**Table 1 List of Comments to Alternative Screening Report in Alphabetical Order**

**Response to Comments from Agencies and Groups  
North Split Alternatives Screening Report**

## Smaller Footprint

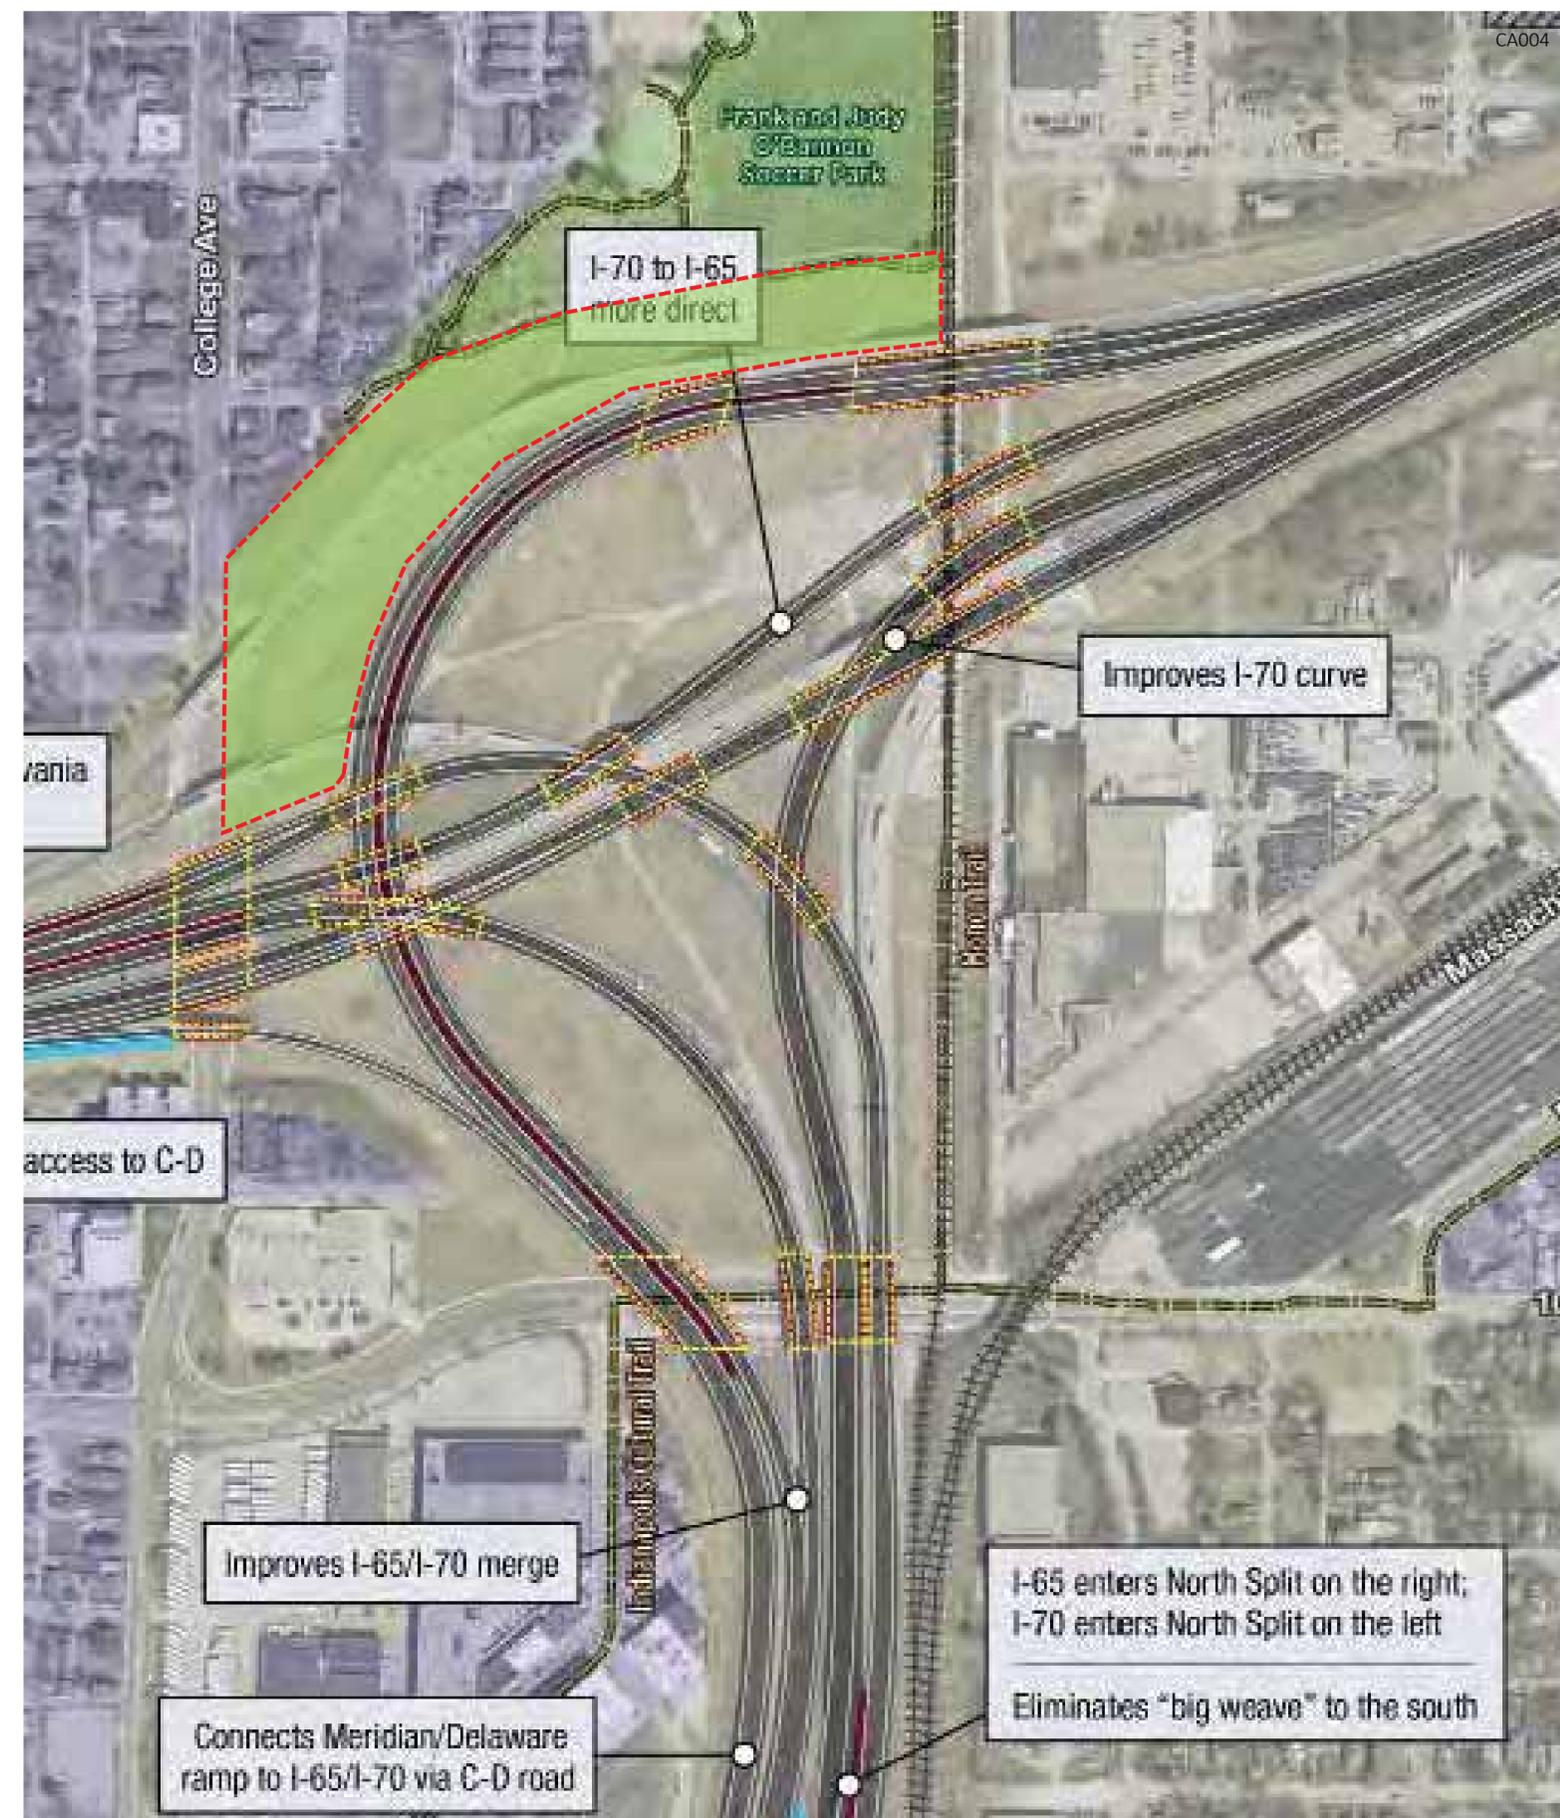
### 4. Inclusive Economic Development Potential?

- *Limited additional land created for park space adjacent to O'Bannon Park on north side of interchange*

## Project Segmentation

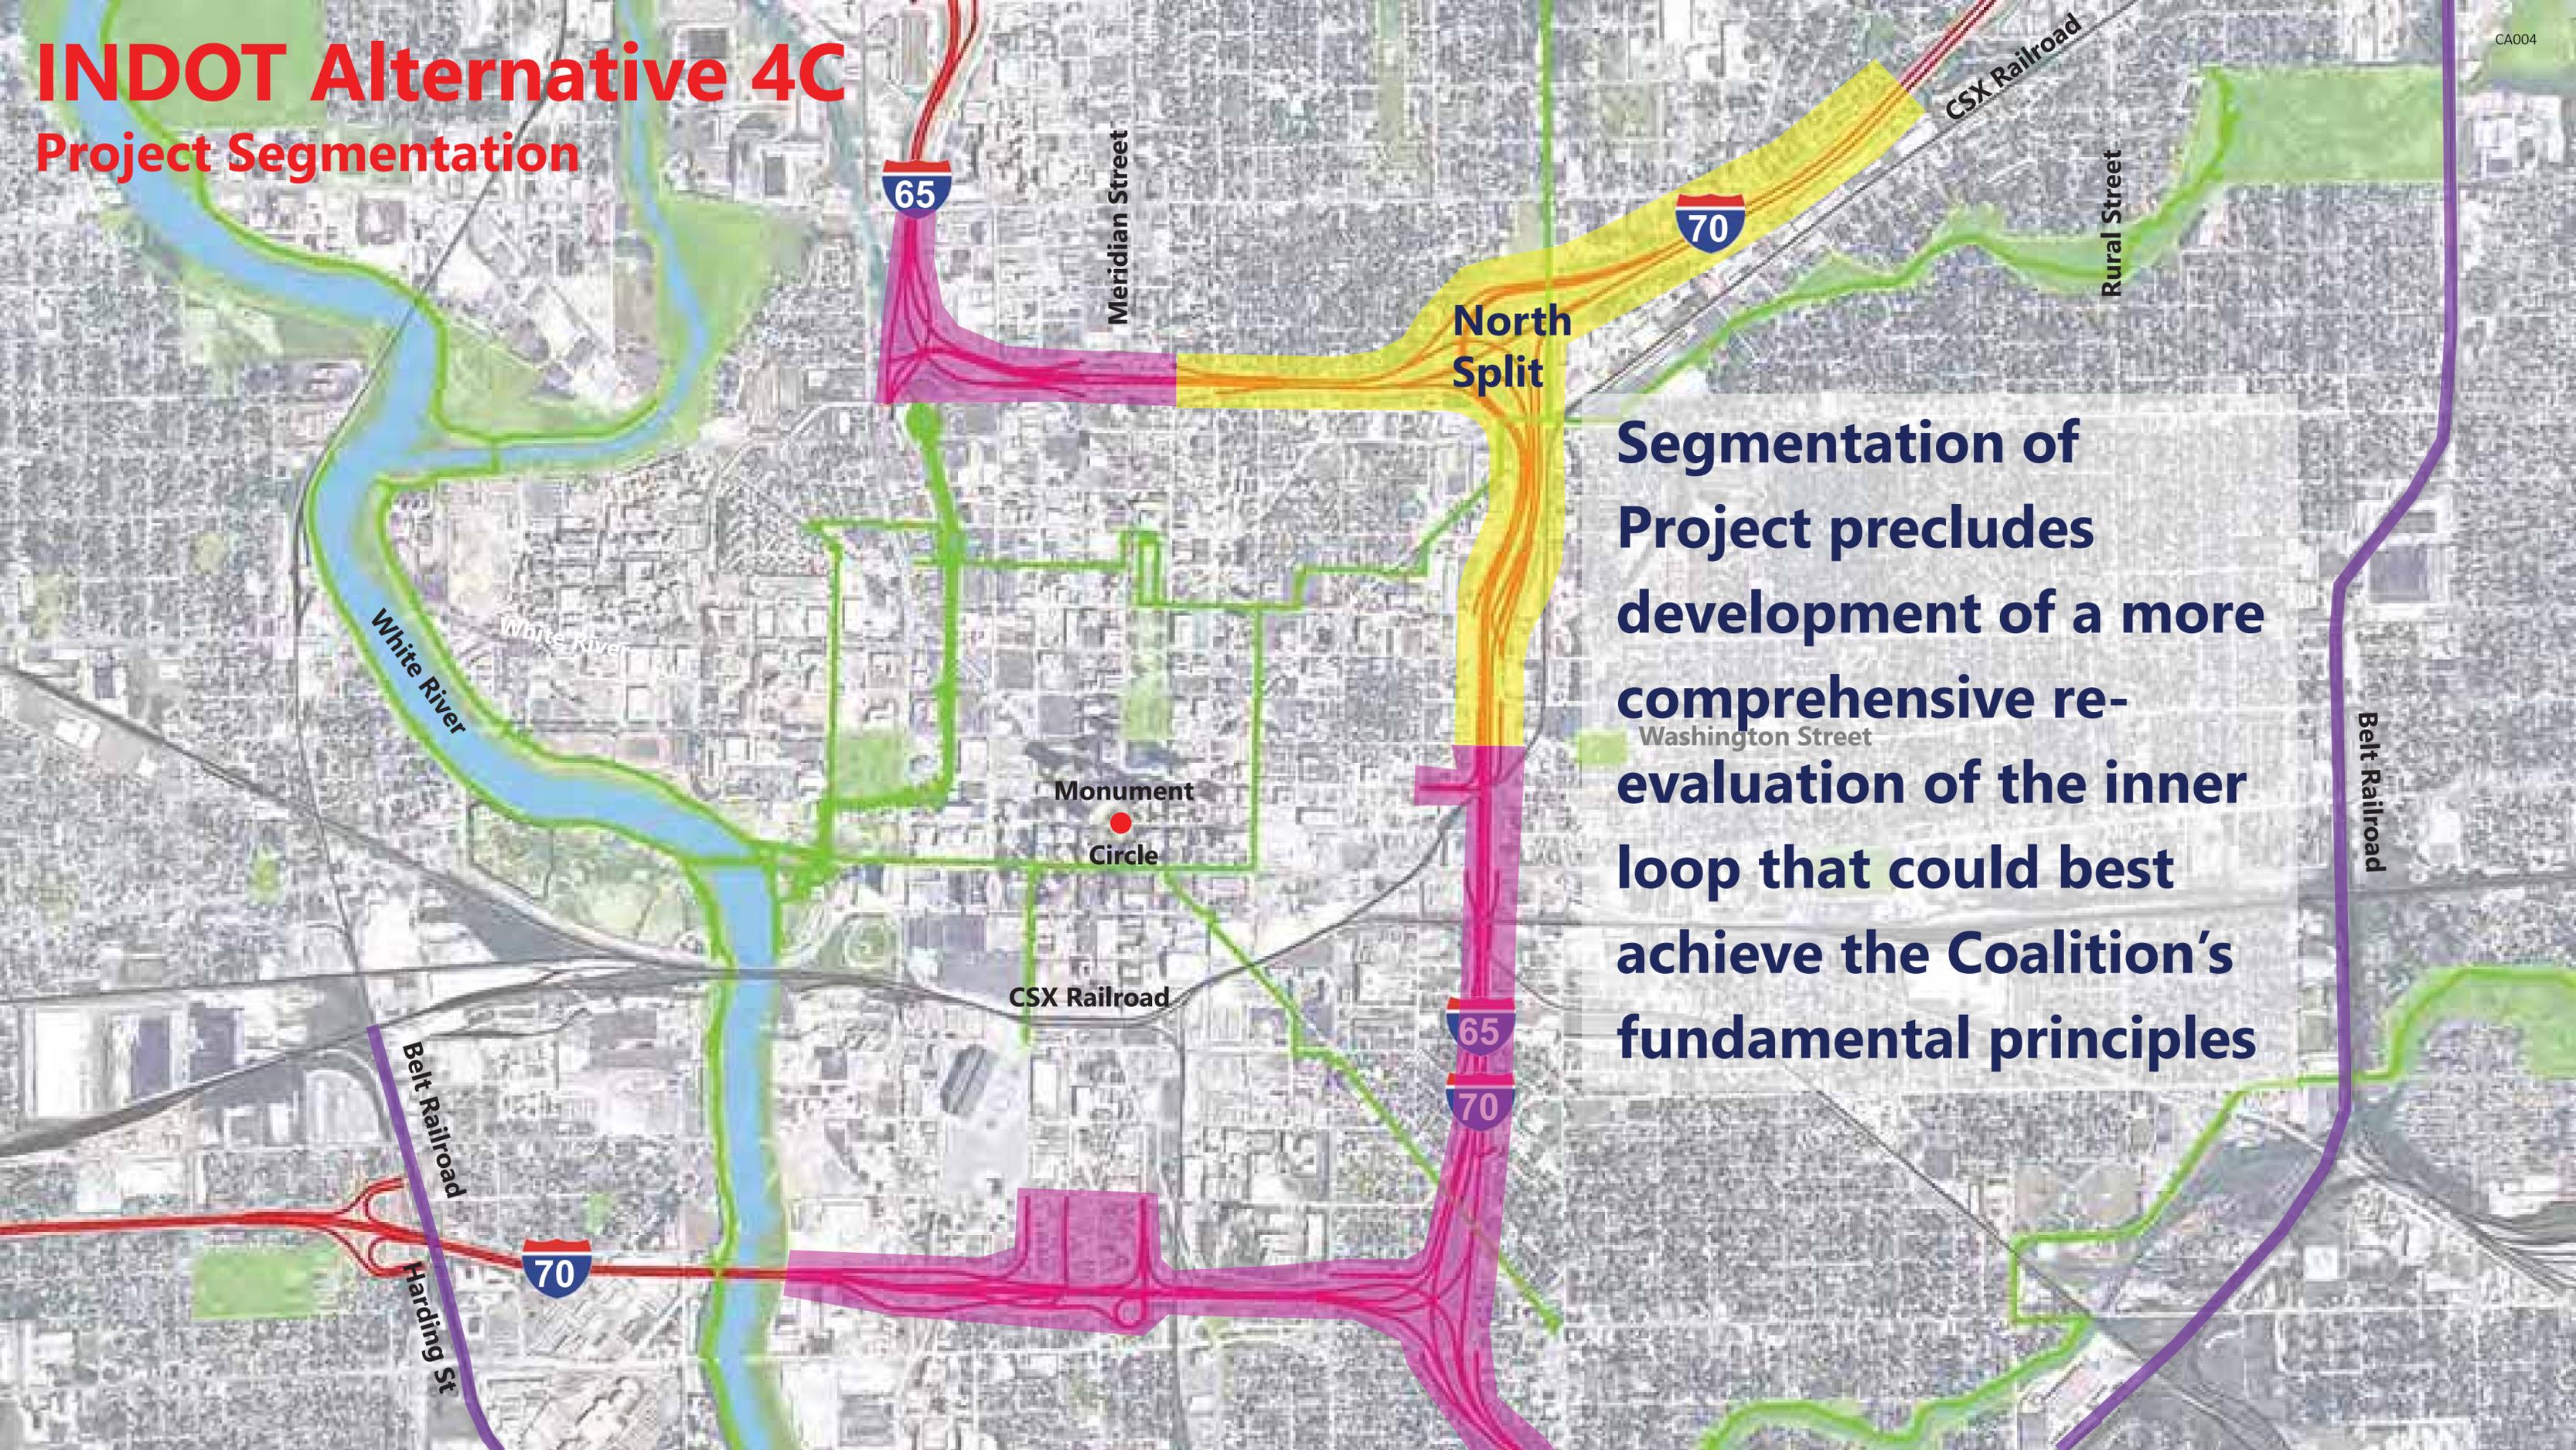
**Segmentation of Project precludes development of a more comprehensive re-evaluation of the inner loop that could best achieve the Coalition's fundamental principles**

Figure 3.1 The North Split Interchange Alternative 4.c

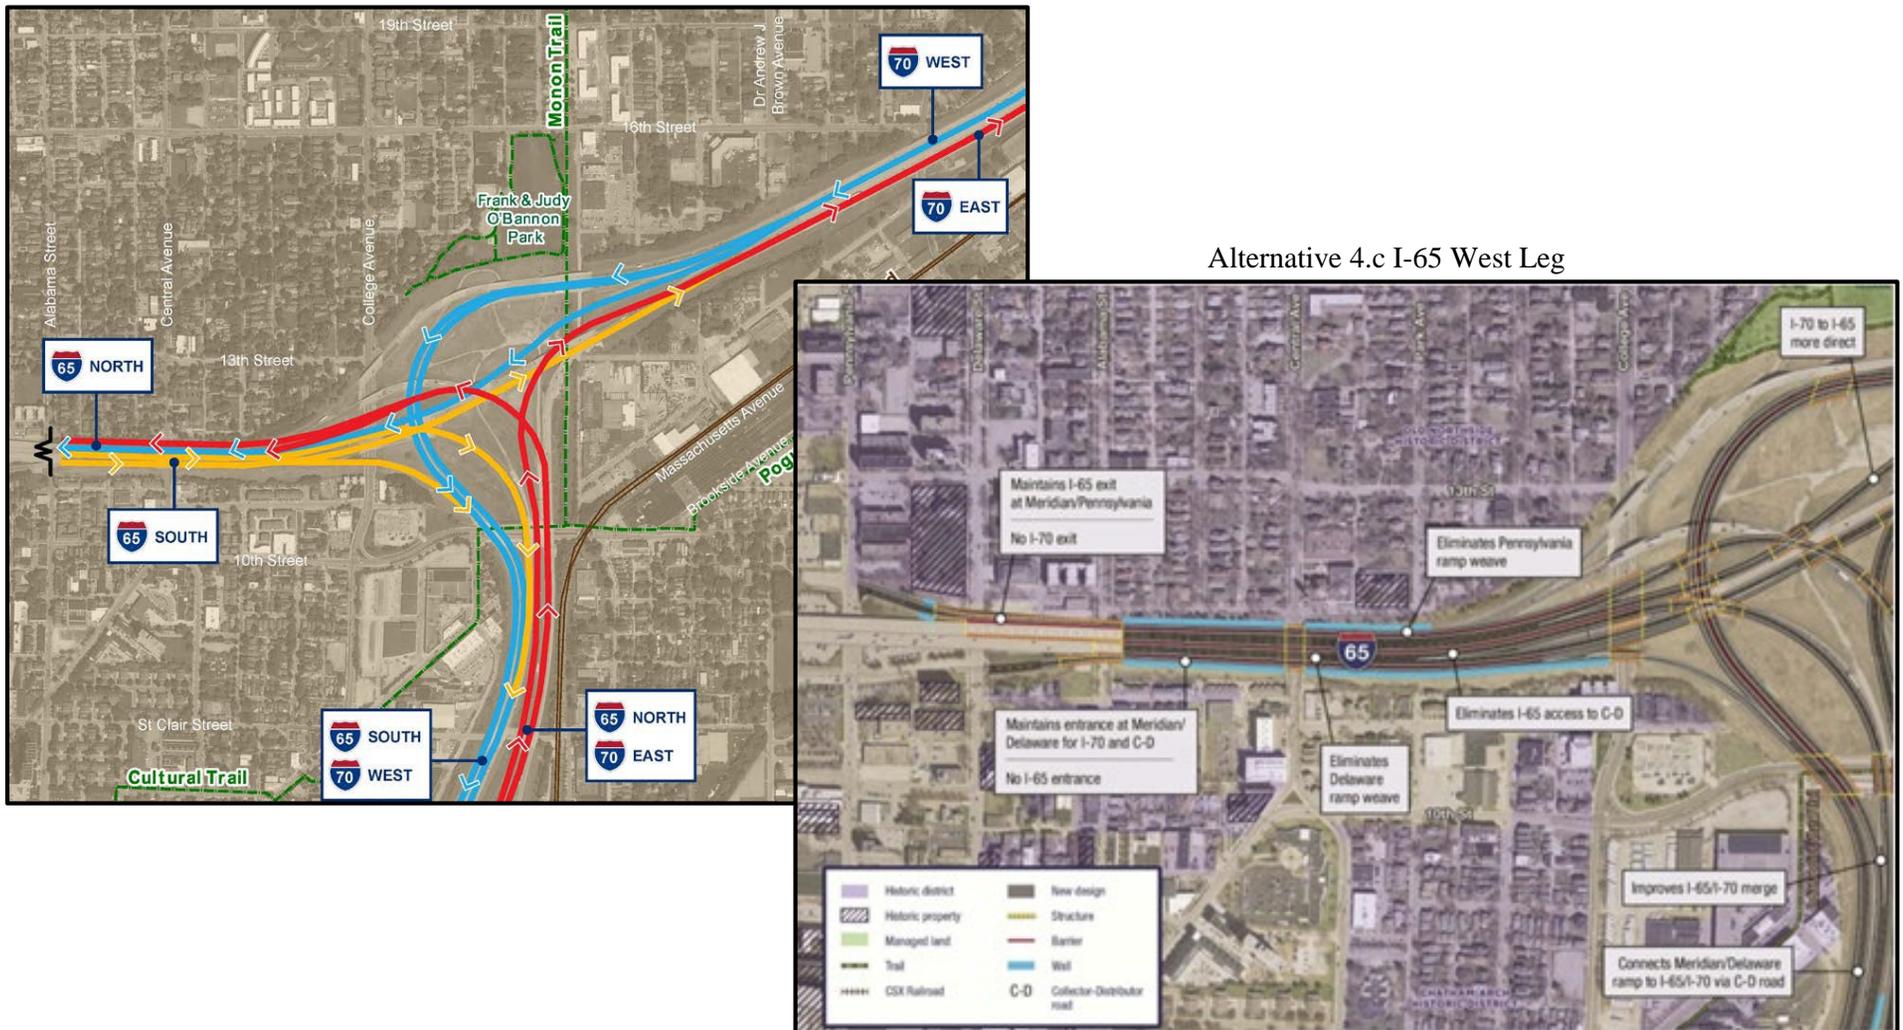
### 3. Comments to INDOT's Preferred Alternative Concept 4.c for North Split Interchange
